TCEP Proj. #038-018-10

ADDENDUM NO. 1

NEBRASKA ARMY NATIONAL GUARD CATS FRONT GATE PROJECT

**CATS Front Gate Project
NEARNG Proj. #31090269**

C105

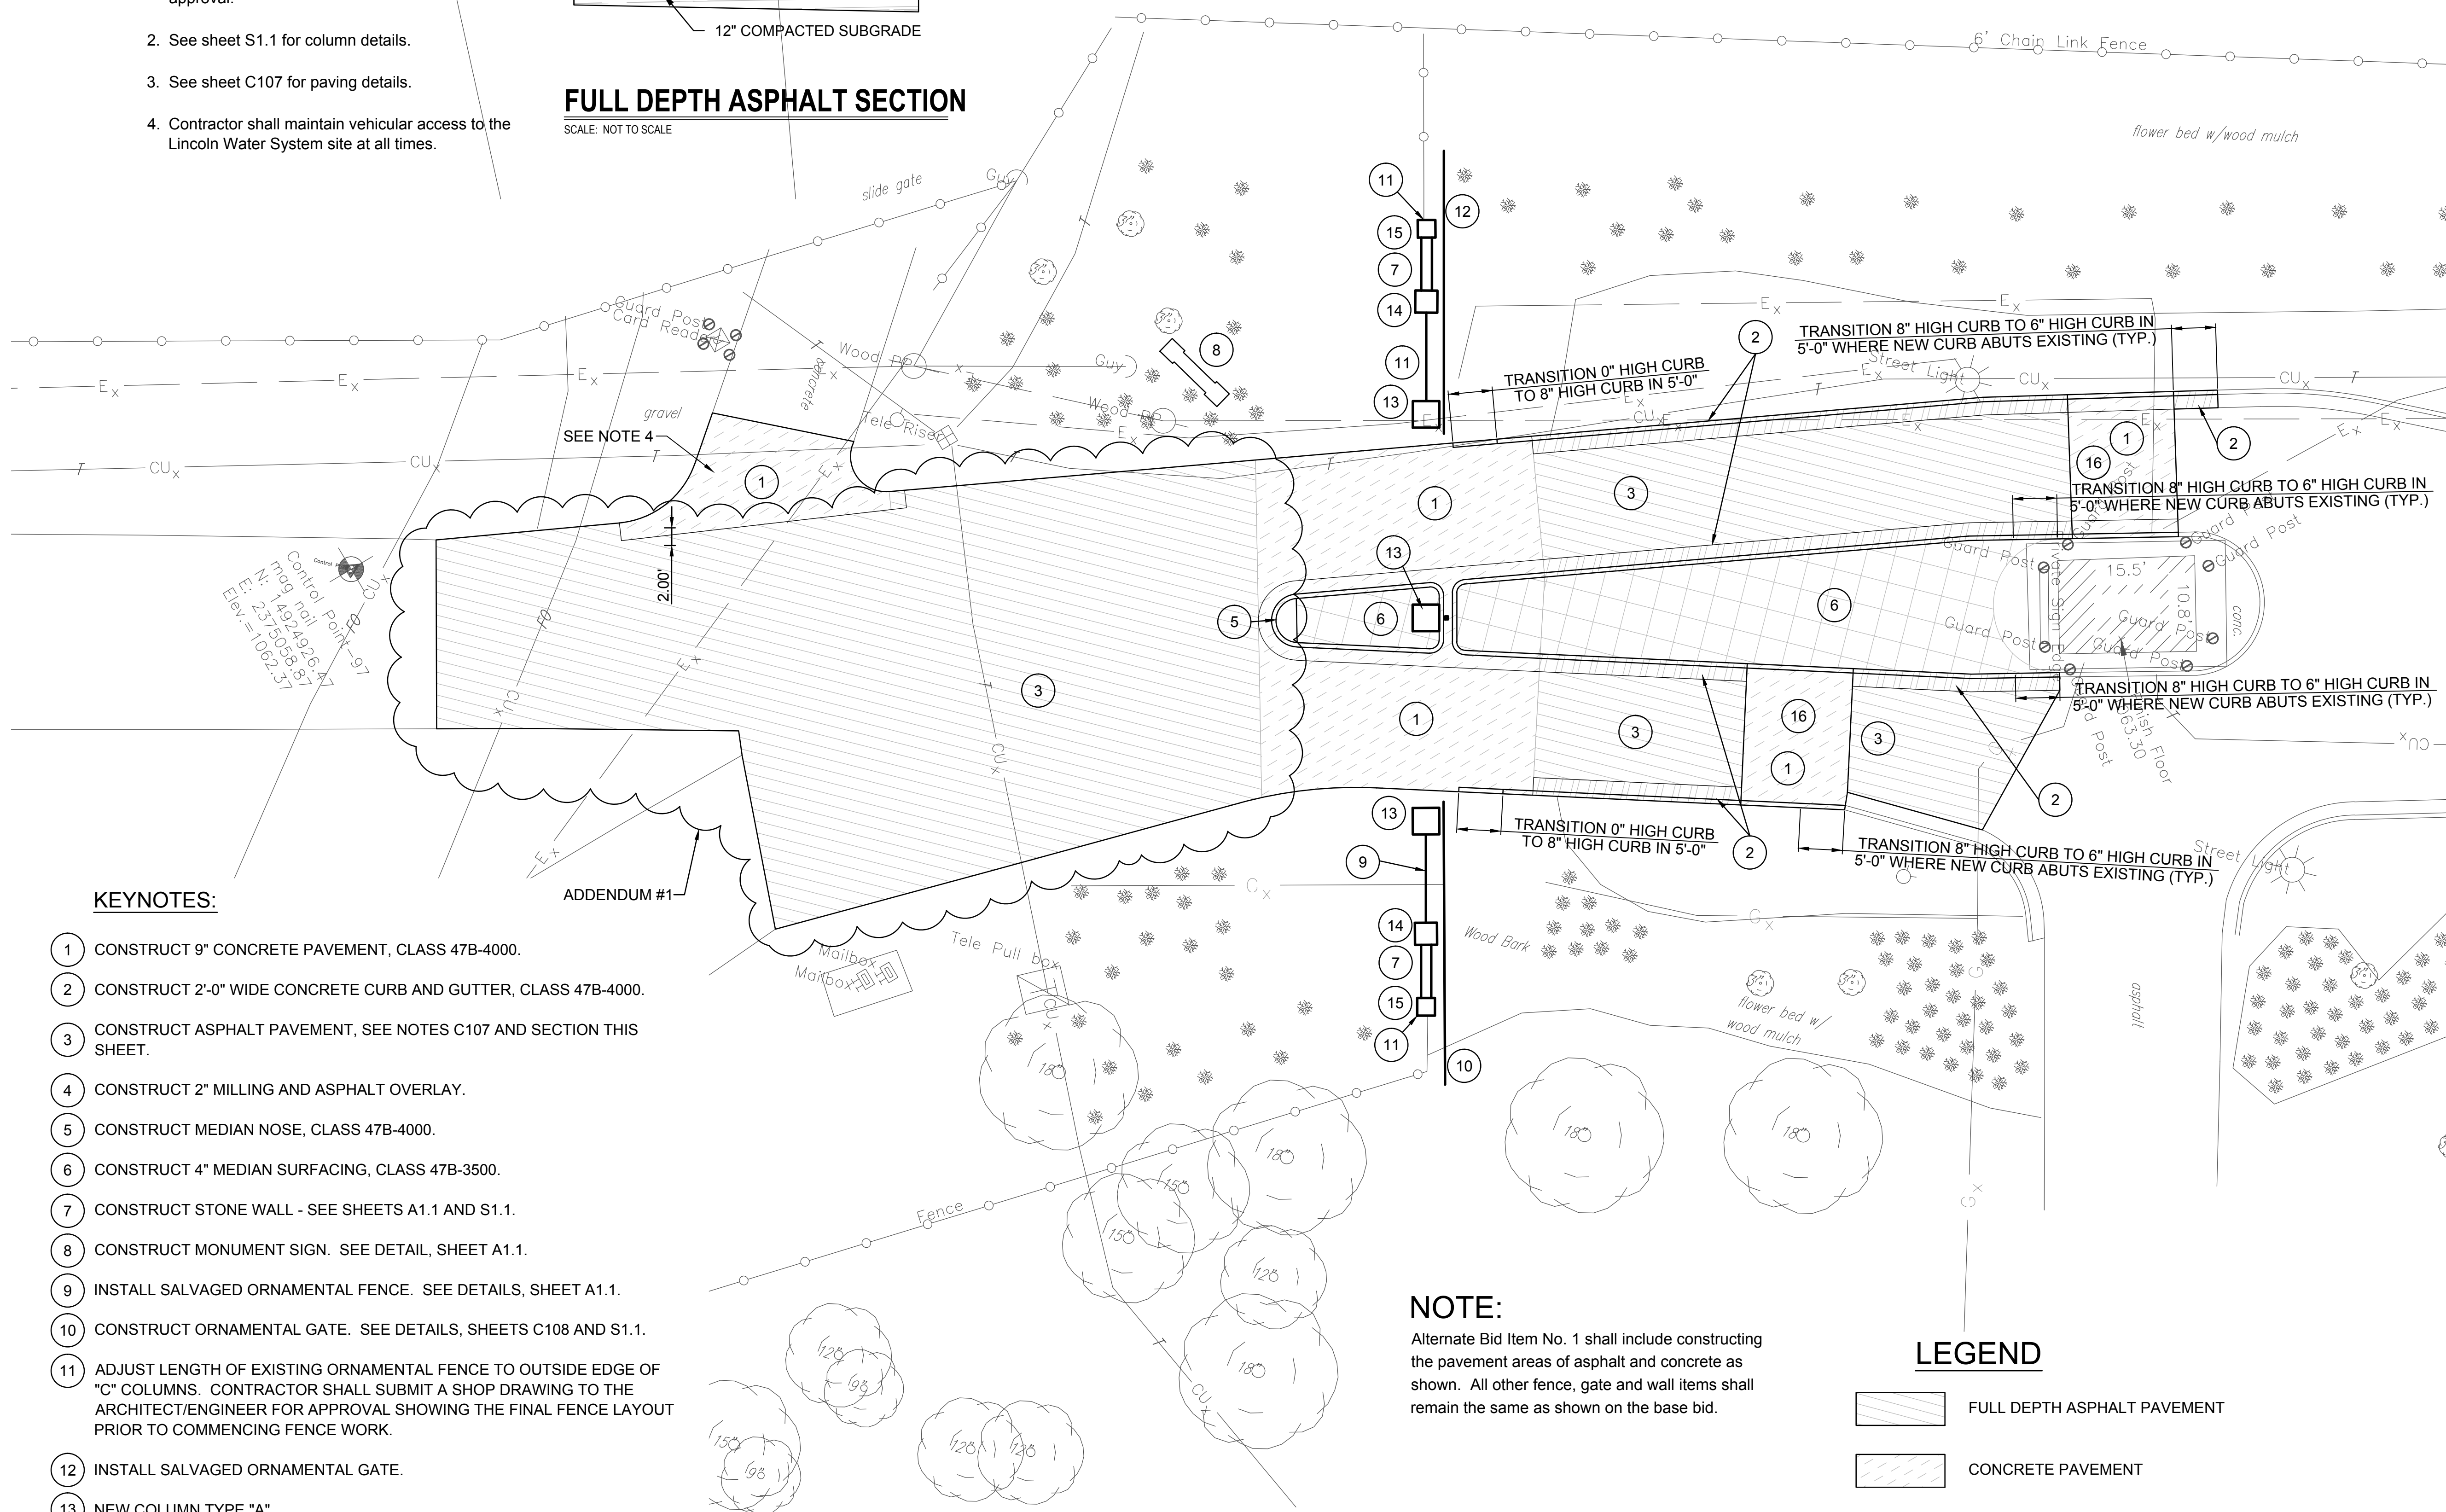
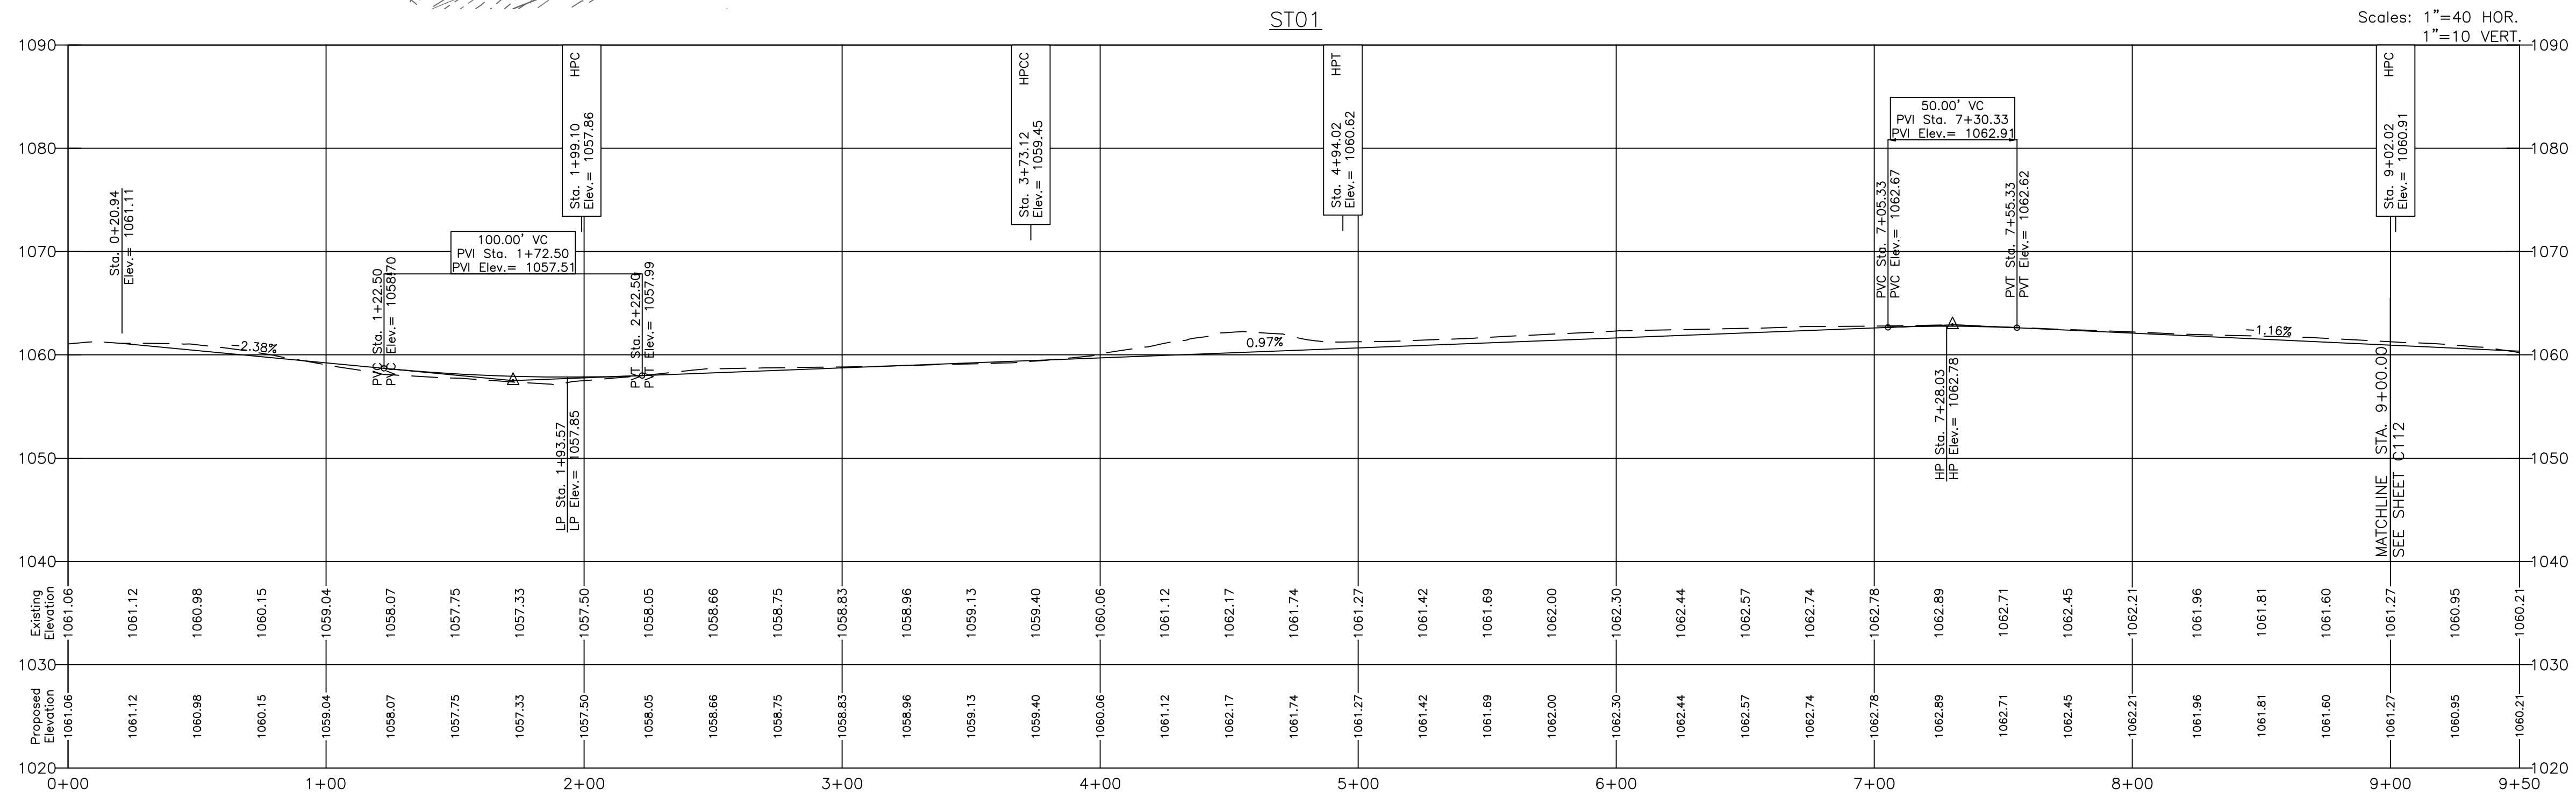
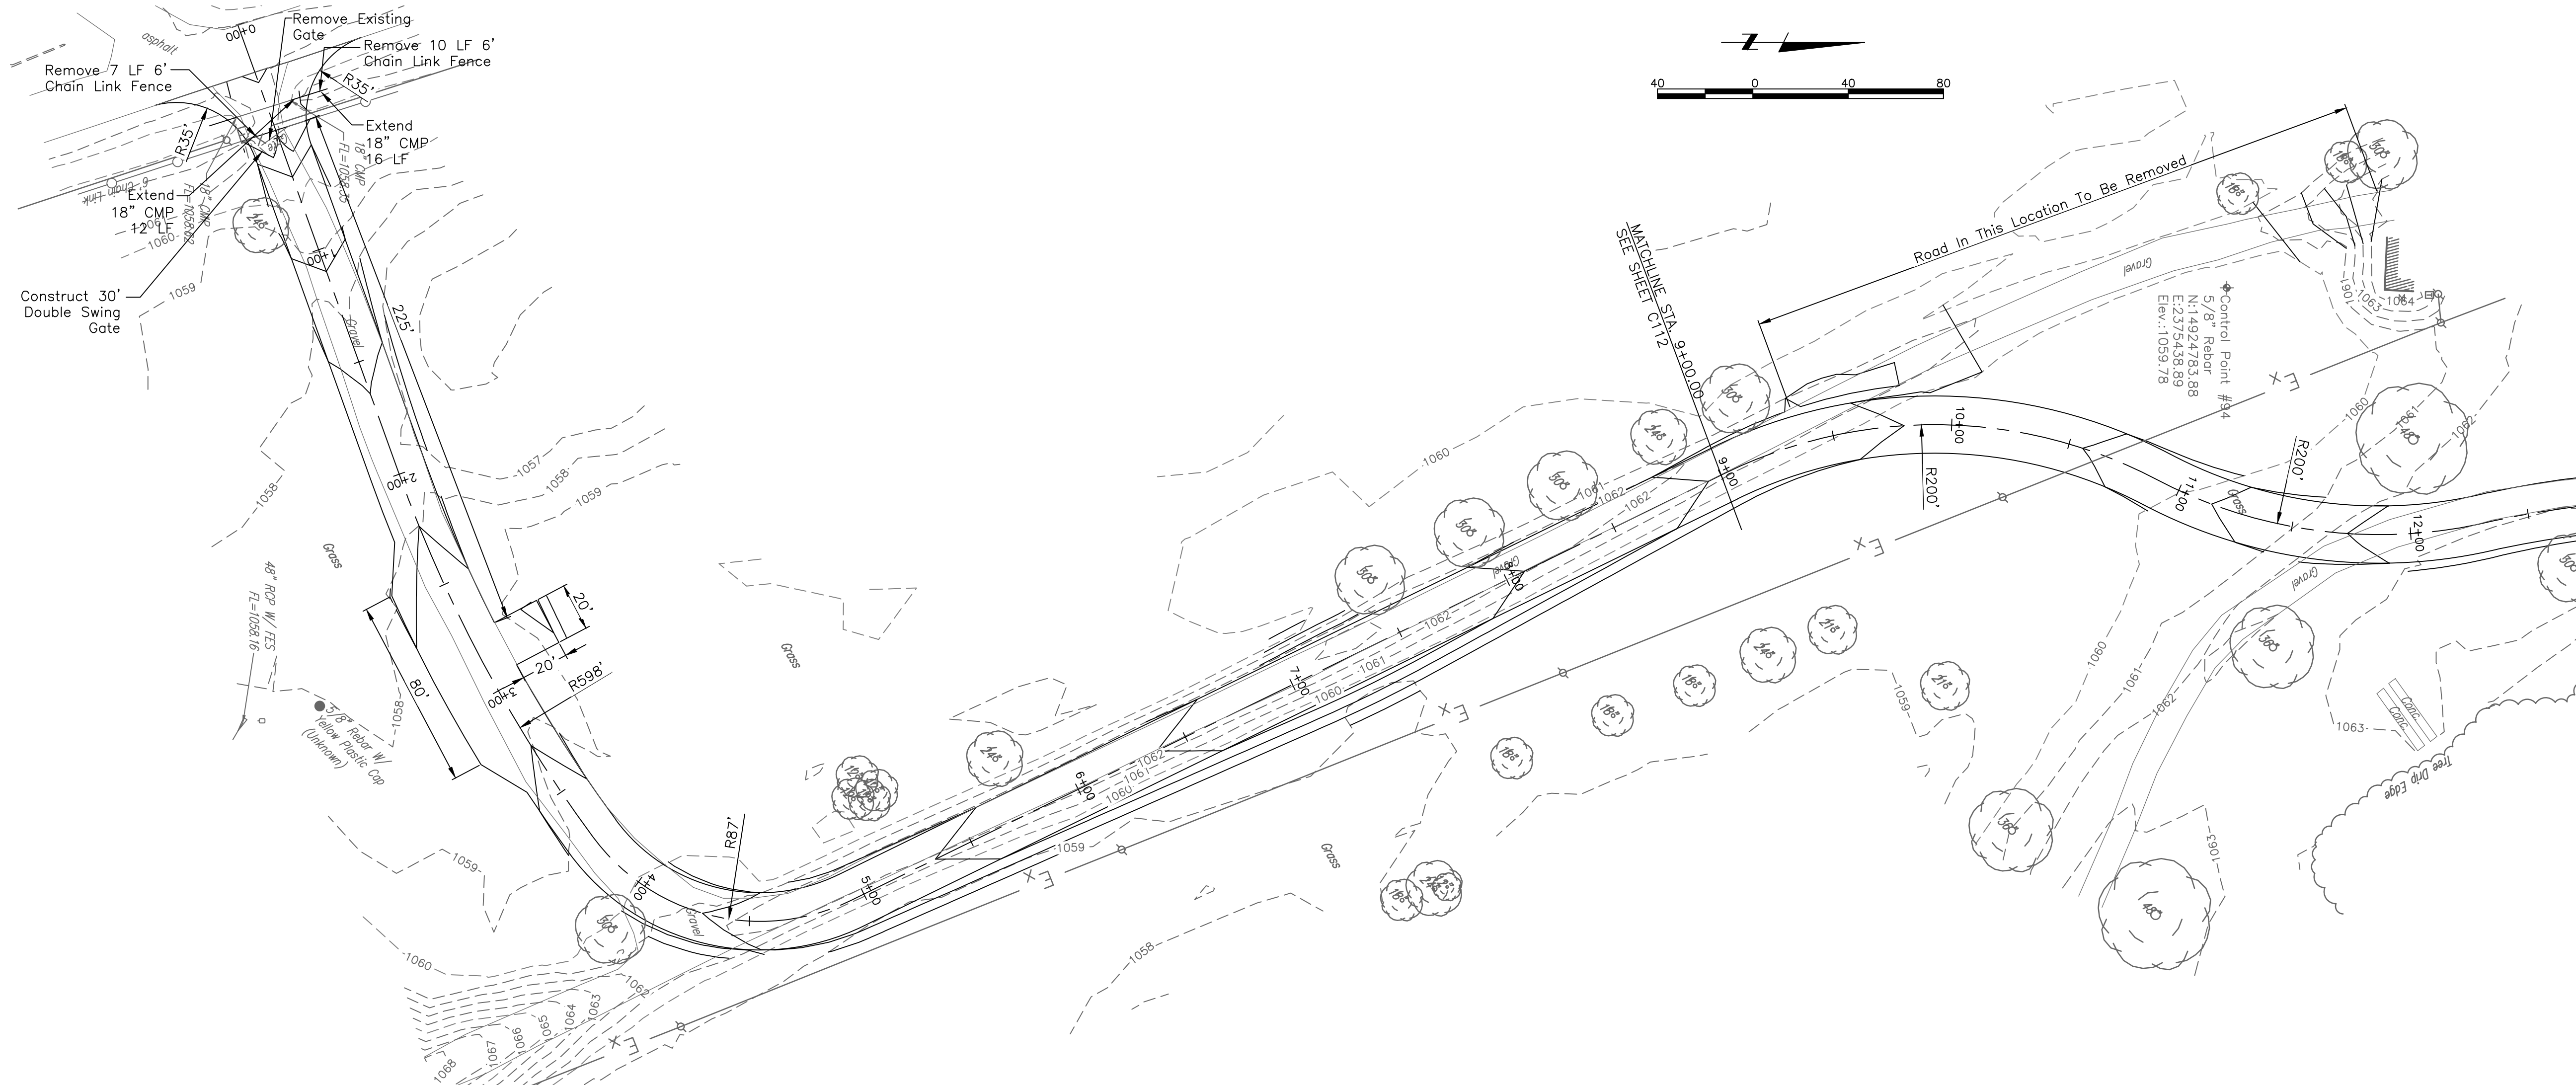
- Refer to Paragraph 3.1.A.1, Revise alternate to read: Provide asphalt paving in lieu of concrete paving as described on the drawings.
- Add Paragraphs 3.1.D and 3.1.D.1 as follows:

Item 1-5: Sheet C105

This sheet has been revised and reissued in its entirety as part of this Addendum.

Alternate Bid Item No. 1 shall include constructing the pavement areas of asphalt and concrete as shown. All other fence, gate and wall items shall remain the same as shown on the base bid.
